Subject: Round 1 Request for Information regarding Updated Site-Specific Performance Assessment, dated October 8, 2012. Radioactive Material License (RML) UT2300249

**ENERGYSOLUTIONS, LLC.  
CLIVE, UTAH  
LOW-LEVEL RADIOACTIVE MATERIAL LICENSE (RML UT2300249)  
UPDATED SITE-SPECIFIC PERFORMANCE ASSESSMENT  
OCTOBER 8, 2012**

**REQUEST FOR INFORMATION**

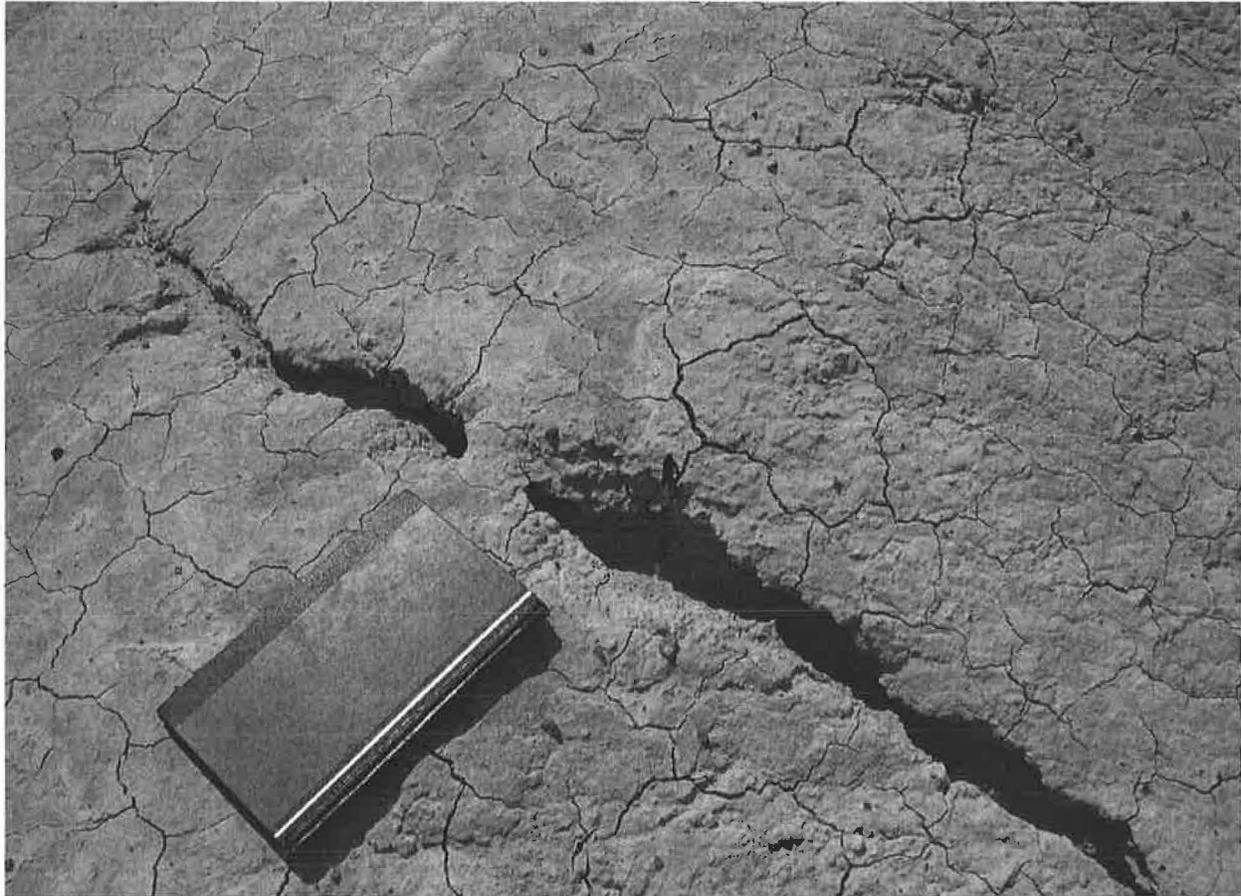
**INTERROGATORY STATEMENT(S):** It is stated on Page 2-6 that "Long-term stabilization of the Embankment is accomplished through erosion control and flood protection."

The statement above that stabilization of the embankment is accomplished over the long-term using erosion control does not appear to be supported by existing data, as noted in the following photos. These photos show that existing erosion control for clay soils on site is in some places only partially effective, and that erosion control needs to be undertaken from year to year. Stabilization now does not necessarily indicate stabilization over time within the modeled timeframe (i.e., 10,000 years). Please either justify the statement above, or revise it to be consistent with existing data.

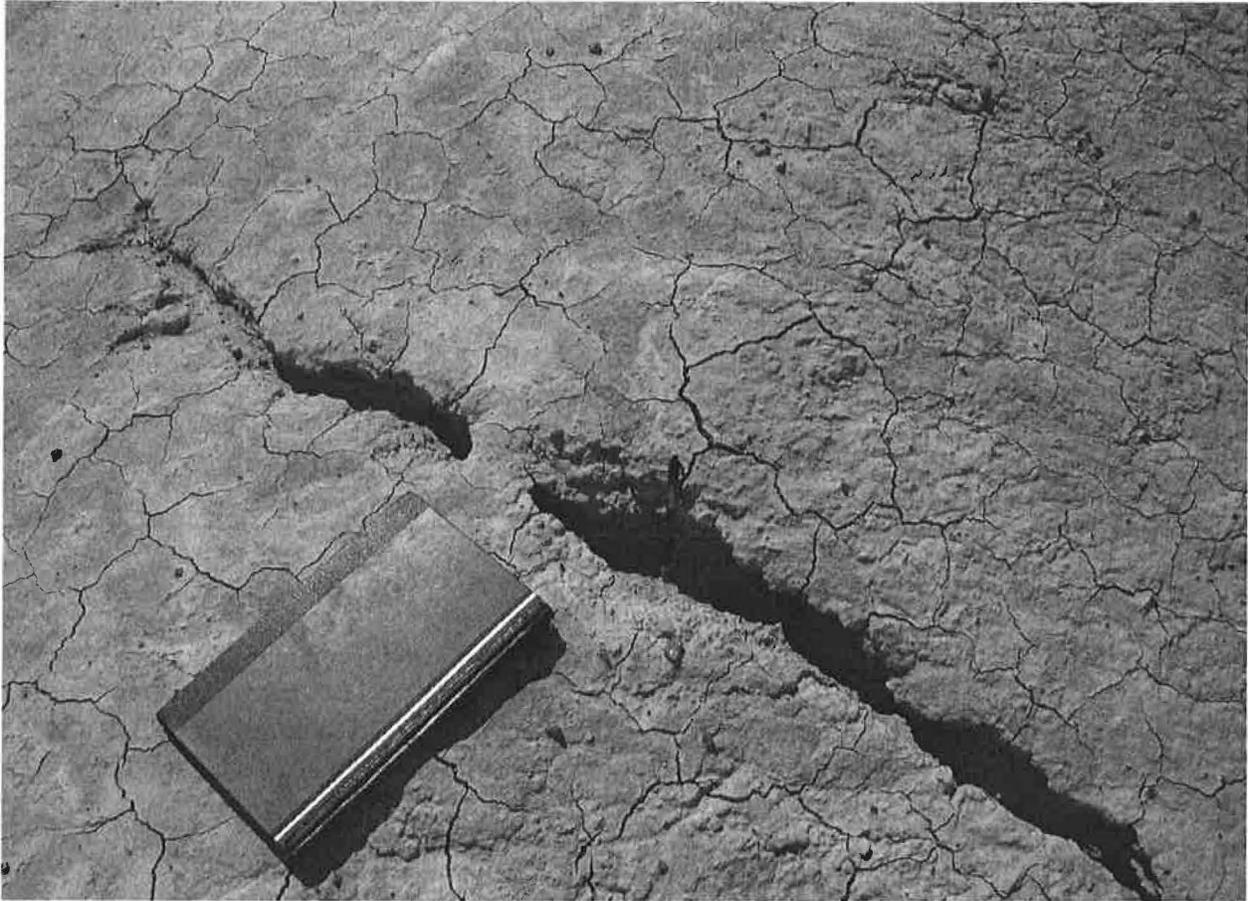
Freeze-thaw activity, frost heave with accompanying desiccation, wet-dry cycling, distortion, plant biointrusion and animal biointrusion each have potential to disrupt the upper radon barrier, leading to its fracture or to other physical or chemical damage. Once damaged, the upper radon barrier, and layers above it, cannot act as the gatekeepers that they are currently envisioned to be in the model in slowing down the vertically downward migration of draining infiltrated water that will pick up radionuclides and eventually flush them down into the groundwater system.

So, does it take 120 to 1,100 years for water to travel one foot through the near-surface clays at Clive? In an imaginary, hypothetical world described in a model, maybe yes. In a real world,

where clays may look like that shown above not only at the surface, but possibly, to some extent, at depth, the answer is likely no.
